**G-01502**  
**February 2001**

**SUBJECT: SAFETY RECALL (U.S., EXPORT)**  
**AUTOMATIC BRAKE ADJUSTER ANCHOR BRACKETS ON**  
**AIR BRAKE VEHICLES WITH LONG STROKE BRAKE**  
**CHAMBERS, EATON / SPICER BRAKES, AND BUILT FROM**  
**10/7/96 THROUGH 11/14/00.**

**FIGURE 1**

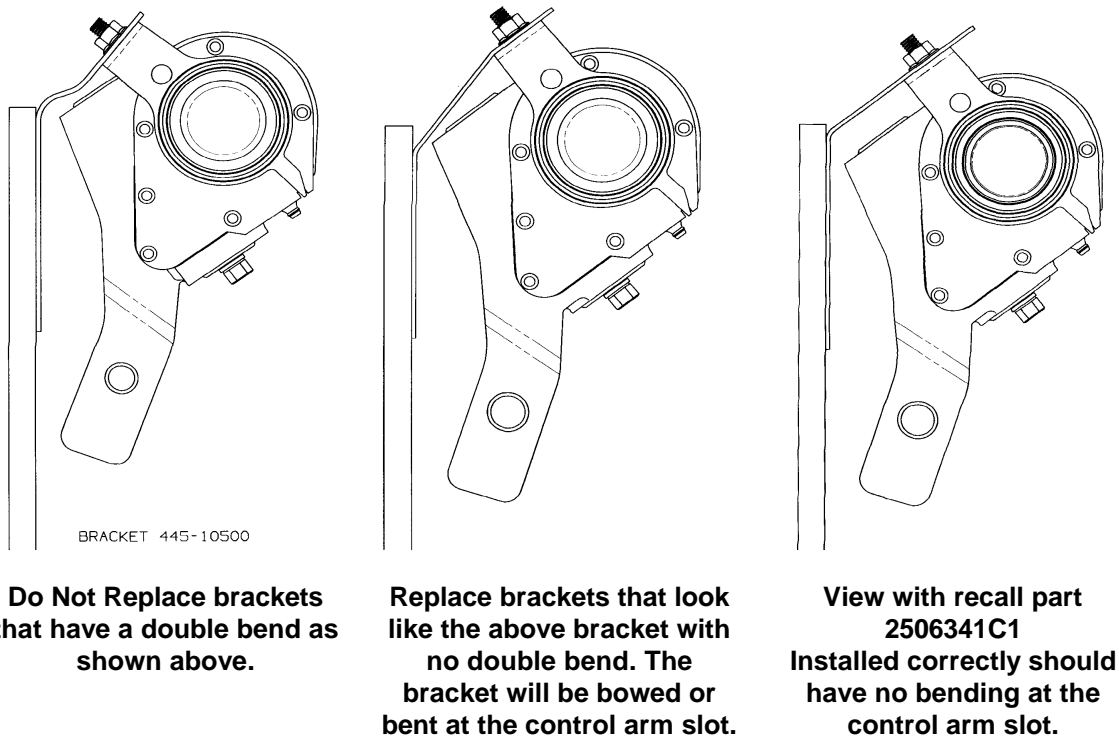
Good brackets have a double bend as shown in the left figure of FIGURE 1 and **may have** a “500” stamped on the longest part of the bracket. **DO NOT REPLACE THESE BRACKETS OR TIGHT OR DRAGGING BRAKES MAY OCCUR.**

Defective brackets **DO NOT have a double bend**. Compare the left figure and the middle figure of FIGURE 1. All defective brackets will look like the one in the middle figure and **may have** a “430” stamped on the longest part of the bracket. **Change all brackets that match this description.**

The replacement bracket supplied for this campaign does not have a double bend like the originally installed good bracket but it is physically different than the defective bracket. When this part is installed correctly there will not be a bend or bow near the control arm stud (see the right figure of FIGURE 1 below).

16. **To position the control arm.** Rotate the control arm counter-clockwise as viewed in FIGURE 1 or away from the adjusting hex and towards the air chamber until it comes to a definite internal stop. If the control arm is mis-positioned, TIGHT BRAKES WILL OCCUR.
17. Install and tighten the control arm nut to 10 – 15 ft-lbs. Assure that the control arm does not move out of position while tightening. Verify that the anchor bracket is not bent or bowed at the control arm slot and that it is correctly installed as shown in the right figure of FIGURE 1.
18. Uncage the brake chamber if caged in step 5.
19. Do not return or reuse the defective brackets, destroy and recycle the defective brackets locally.
